**Re: Horizon 3**  
**8830 horizon Blvd NE Albuquerque NM**  
**Traffic Circulation Layout**  
Engineer's/Architect's Stamp **05-28-2019** (C17D127)

Based upon the information provided in your submittal received 06-05-19, the above referenced plan cannot be approved for Building Permit until the following comments are addressed:

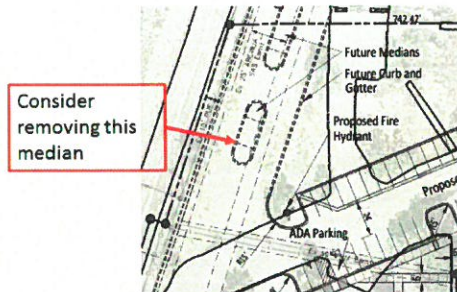
3. Consider removing one of the medians. The access road must transition after the site access intersection.

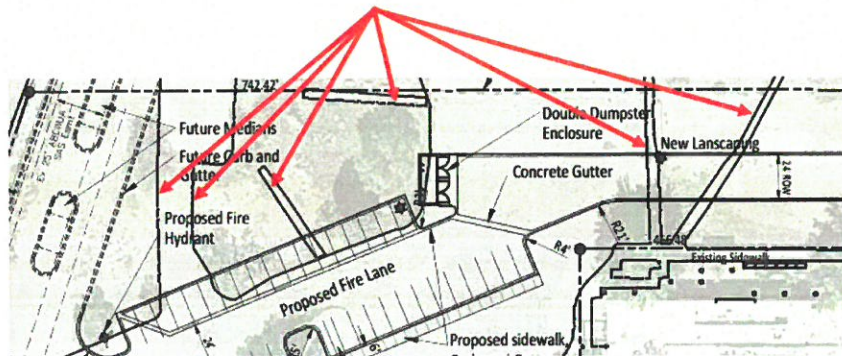
4. Please clarify if these features are being removed.
